**SUBJECT: Comments on Tentative Waste Discharge Requirements
City of Sacramento Department of Utilities/
Sylvia Dellar Survivor's Trust
Dellar Landfill, Sacramento, California**

Re: Tentative Waste Discharge Requirements
City of Sacramento Department of Utilities
Sylvia Dellar Survivor's Trust

**Re: Dellar Trust Property Closure Construction Project
Sacramento, California**

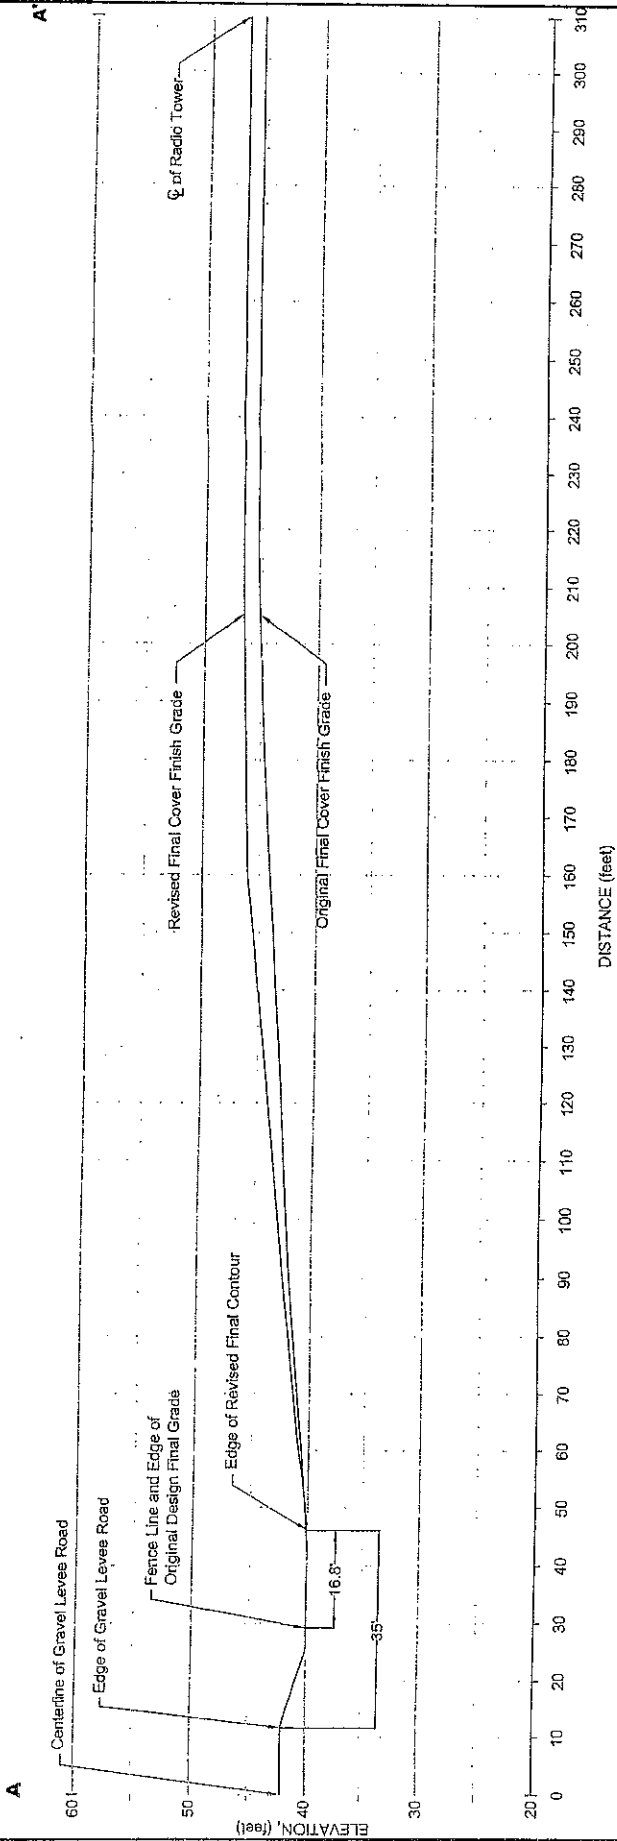
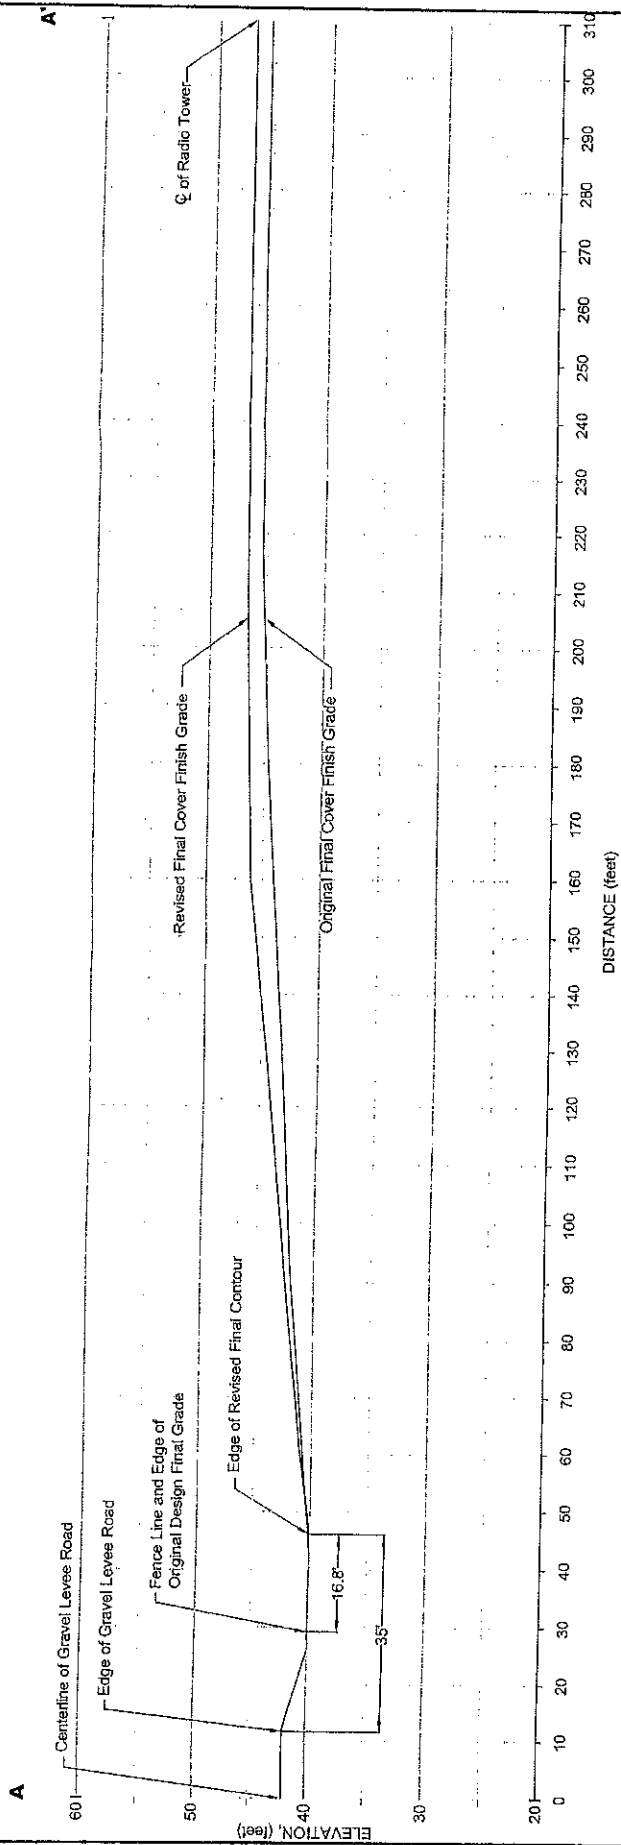
As a result, the northern toe of the final cover was moved as shown in the revised grading plan (Attachment C). This new version of the grading plan also shows some minor topographic changes needed to obtain a better earthworks balance for the project and to improve drainage. Plate 1 (attached) shows a cross-section comparing the original design and the revised design at the northern end of the Dellar property between the radio tower and the gravel levee road. There is little difference between the original design and the revised design.

We have continued with construction using the revised grading plan. I have been instructed by the Trustee to request your written approval of this modification to the grading plan. This letter is subject to the limitations in Attachment D.
